PFA Grant Amendment Request

Yes. The recently completed 90% designs include the following changes from the 60% designs submitted with the grant application. (Changes are indicated on the attached Exhibit C - 90% Plan Set by their associated numbers in this amendment and organized by their relative location within the Project Area):

CONYERS CREEK HABITAT DIVERSIFICATION AND ENHANCEMENT PROJECT

90% DESIGN SUBMITTAL - REVISION 1

LOWER REACH PLAN
SCALE: 1" = 20'

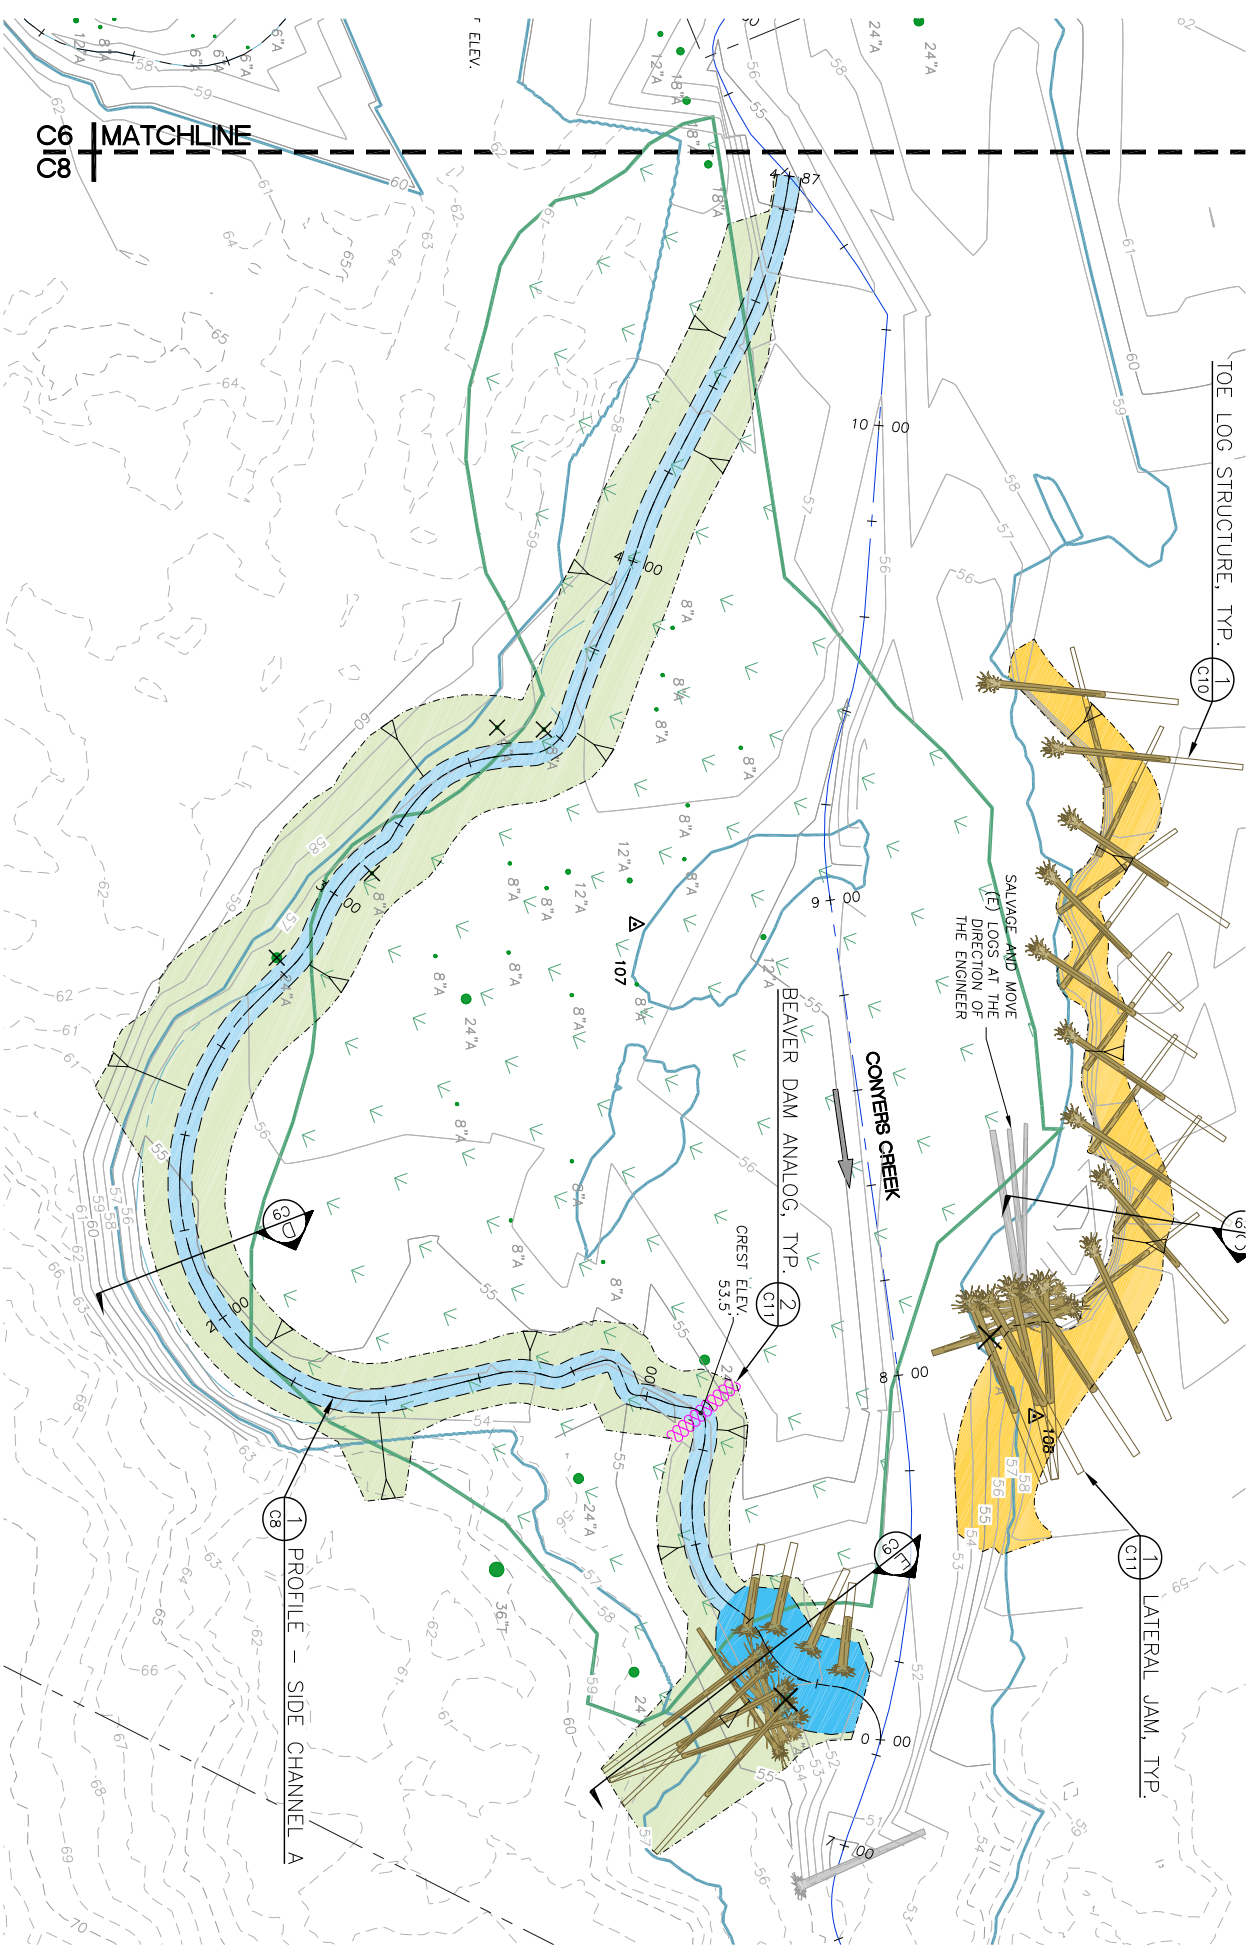
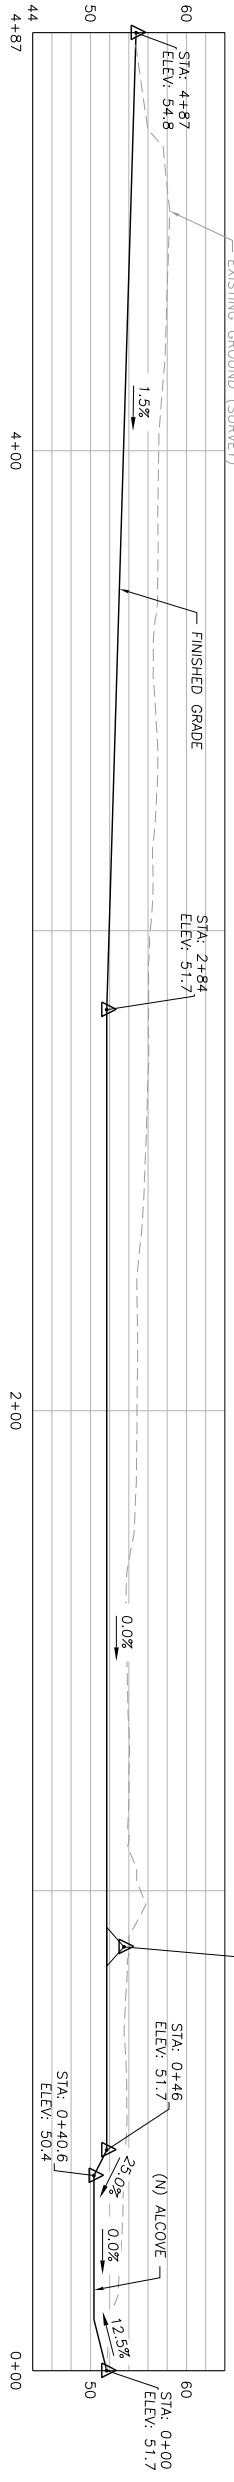
- 9) Modified: The number of BDAs in Side Channel A has been reduced from 3 to 1.
- 10) Added: Another ~40' of bank layback area has been added to the NW bank of Conyers Creek upstream of the log structure location. Work will include installing a row of single rootwads along the toe of the bank terminating in a complex log structure, in similar fashion to the upstream bank layback area.

11) Modified: A complex log structure has been added to the downstream Side Channel A “alcove.”

9) BDA reduction in Side Channel A. The design team has reached the conclusion that 1 structure for the size of the channel and flow volume is a more appropriate use of resources. More structures could have the undesirable effect of backing up water to the confluence with Conyers Creek, negating some of the positive impacts of restoring this side channel. The BDA design for all 3 remaining structures has been modified from complete living structures to a hybrid structure with living stakes along the ends only. The purpose of this is to prevent the BDAs from possibly becoming a fish passage barrier due to aggressive willow growth, while providing additional stability

10) Adding 40' of bank layback with rootwads just downstream of original bank layback area. Both sections of streambank are experiencing severe erosion. Log structures in both layback sections will be installed where pools currently exist for added habitat value. Increasing the area treated with large wood will enhance the overall habitat value of the project and create more long term benefits for fish and other aquatic organisms that include slowing flow velocities, increasing gravel retention, encouraging greater floodplain engagement, and improving water quality.

3) Middle Project Reach #1: Roaring Creek Reconnection – Work Removed

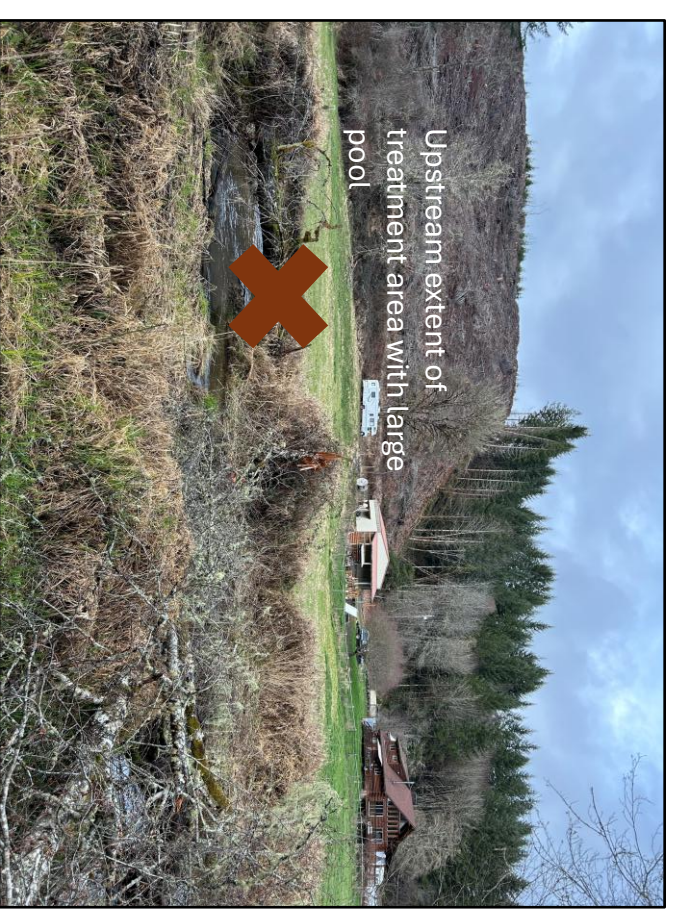
- 1) Roaring Creek historic channel reconnection eliminated from designs due to severe erosion on Conyers Creek cutting into historic channel
- 2) BDAS removed from Roaring Creek channel due to removal of channel reconnection from designs
